**STAFF REPORT  
FOR THE PLANNING COMMISSION**

**FILE NUMBER:** SUB-13-04  
**HEARING DATE:** December 18, 2013  
**REQUEST:** 11-lot subdivision  
**APPROVAL CRITERIA:** Community Development Code (CDC) Chapter 12, Single-Family Residential Detached and Attached, R-7; Chapter 85 Land Division General Provisions.  
**STAFF REPORT PREPARED BY:** Peter Spir, Associate Planner

**Project Description:** The applicant proposes an 11-lot subdivision south of Weatherhill Road. Lots will range in size from 7,018 to 10,899 square feet. The zoning is R-7 (7,000 square foot minimum lot size/single family residential).

SHEET TITLE  
TREE PLAN  
SHEET NUMBER  
C1.2

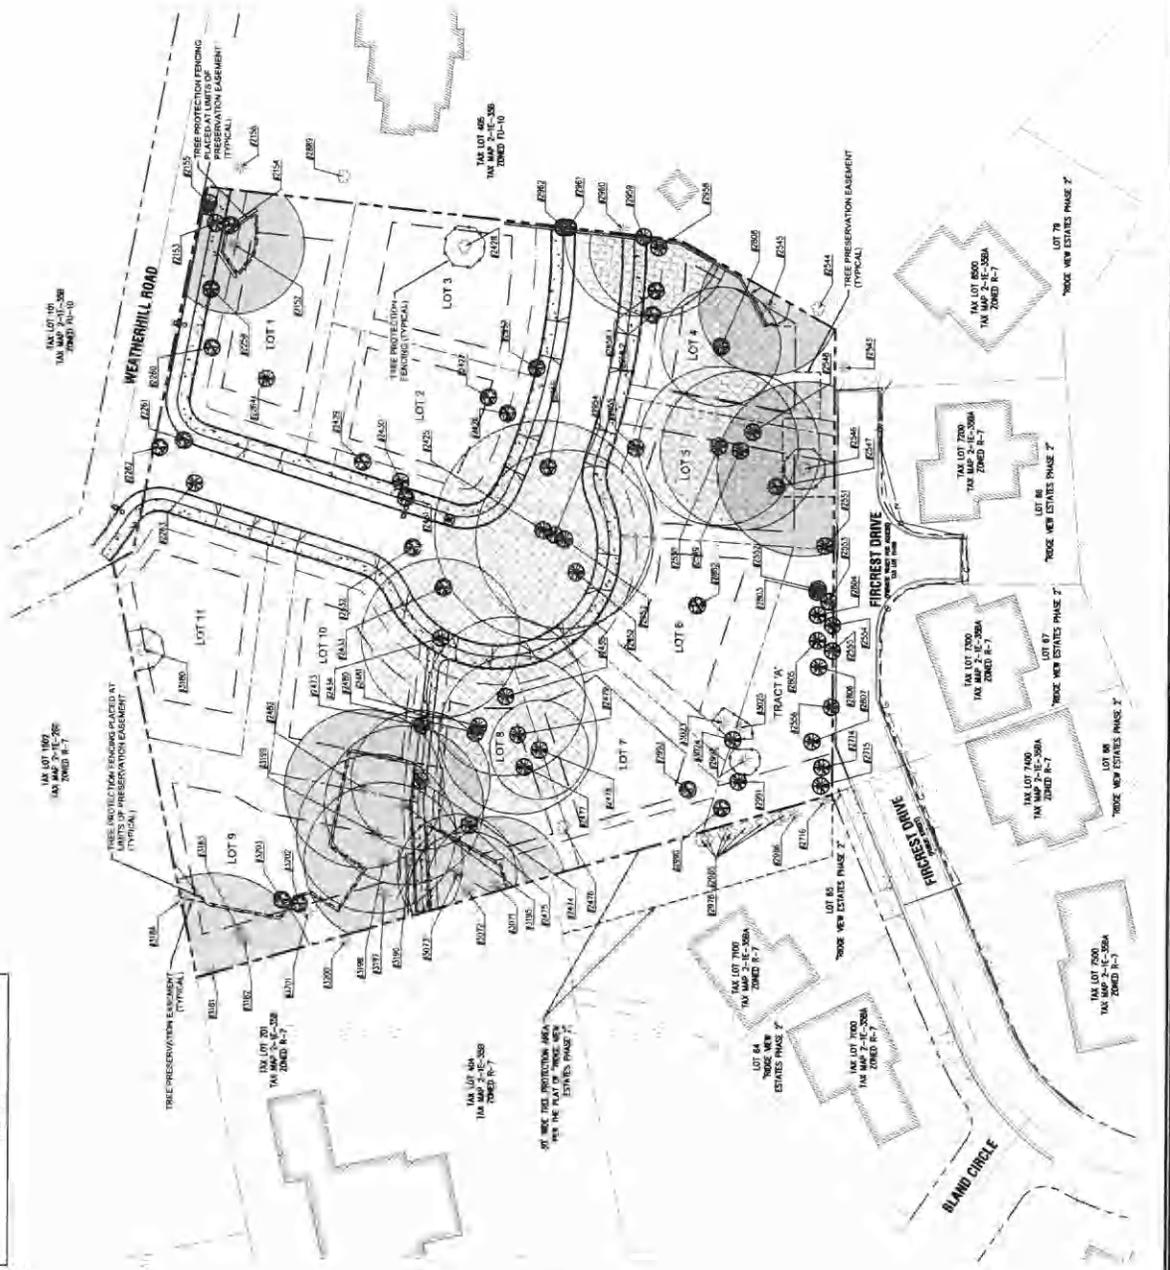
**Staff Response 35:** There are no heritage trees on site. The City Arborist agrees with the applicant's Tree Plan, Sheet C1.2 as to which trees are significant. That plan shows 23 significant trees of which 11 will be preserved. Twelve will be removed to accommodate the required street connection, lot development and the associated grading, especially on the lots below the street. Of the 12 trees to be removed, four are within the proposed street ROW and require mitigation on a one-to-one basis. The trees are 2959(42"), 2425(54"), 2953(36") and 2434(30"). These trees comprise 162 inches, so an equal caliper amount of new trees shall be planted on site (in addition to proposed street trees) and/or on City-owned land as approved by the Parks and Recreation Department. Staff determines that the criterion is met upon the inclusion of Condition of Approval 3.

3. Significant trees to be removed for street construction shall be mitigated for on an inch-to-inch basis and planted on site (in addition to proposed street trees) and/or on City-owned land as approved by the Parks and Recreation Department. A revised street tree plan shall be provided.
